Rezoning Transportation Analysis

Petition Number: 2021-154

From: Brandon Brezeale, PE

Reviewer:

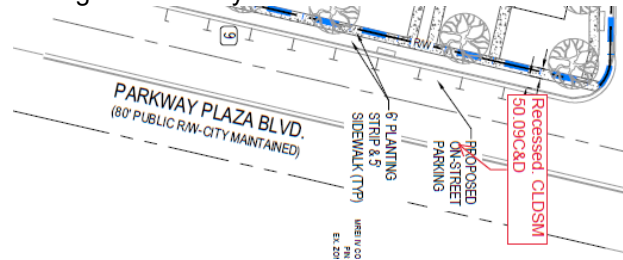
3. ~~Revise site plan and conditional note III.d to commit to construct an 8-foot planting strip and 6-foot sidewalk along the site's frontage of Price Lane and Parkway Plaza Boulevard. The site plan shall label and dimension both items from the back of curb and gutter and road centerline.~~

d. The Petitioner shall construct a minimum of six (6) foot wide planting strip and five (5) foot wide sidewalk along the Site's frontage of Price Lane as generally depicted on the Rezoning Plan.

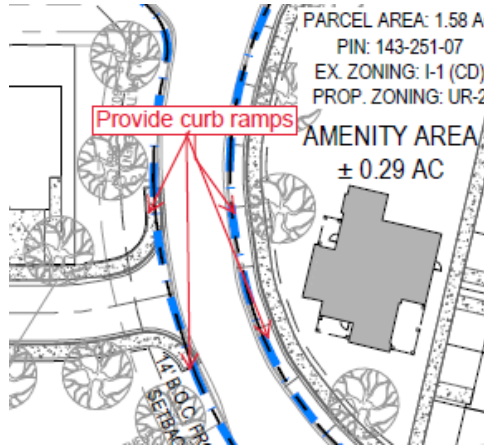
5. ~~Revise the site plan by showing the missing 8 townhomes.~~

Please show the 8 units on the site plan

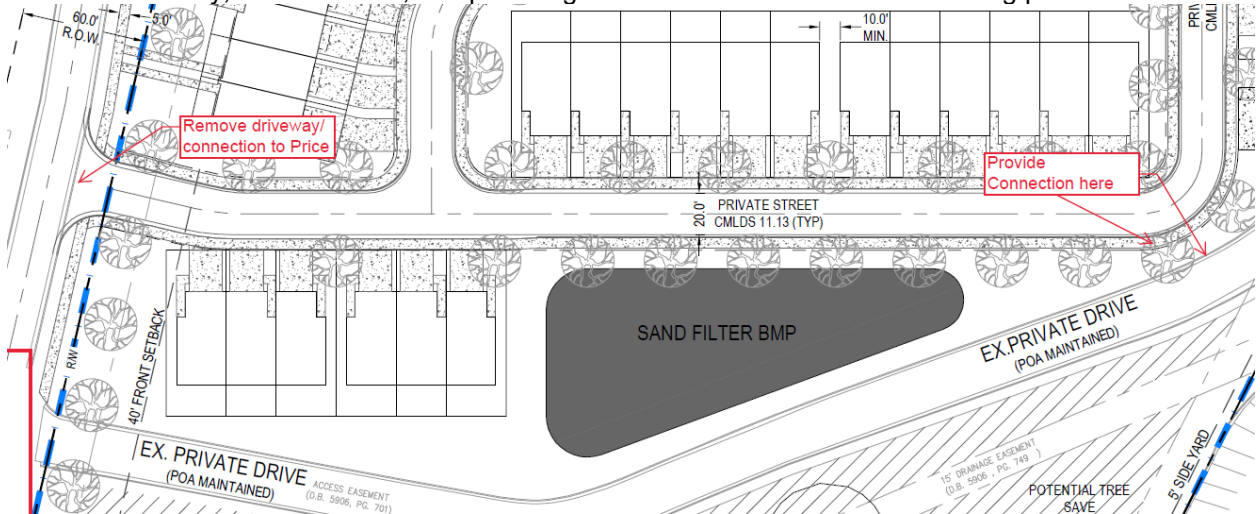
6. ~~Revise the site plan to commit to provide four ADA curb ramps at the proposed private street intersection near the amenity area.~~

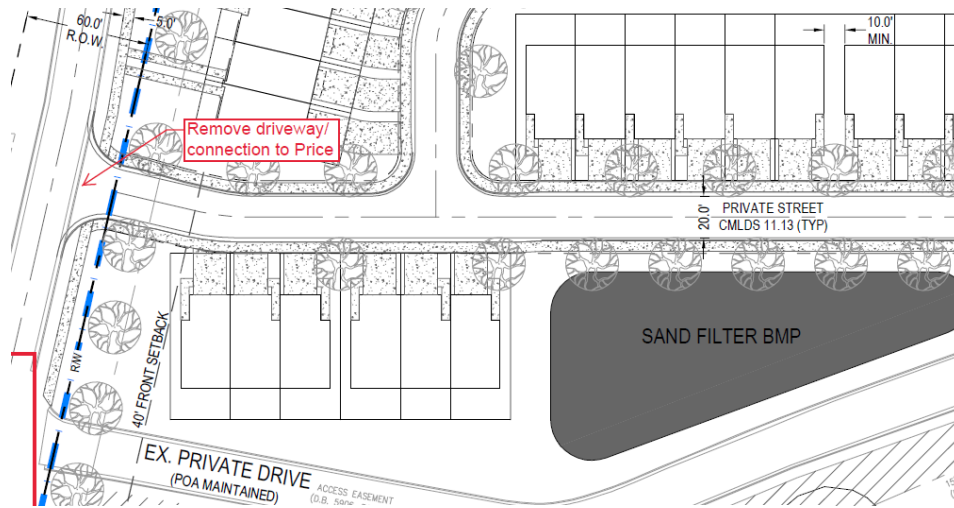
7. ~~Revise the site plan by modifying the proposed internal private street network by removing the proposed southern driveway, on Price Lane, and providing an internal connection to the existing private street.~~

Comment rescinded after coordination with the petitioner: Update to Comment from 01-17-2022 Site Plan: Revise the site plan and conditional note III.b by removing the proposed southern driveway on Price Lane.

b. The maximum number of access points on Price Lane shall be two (2).
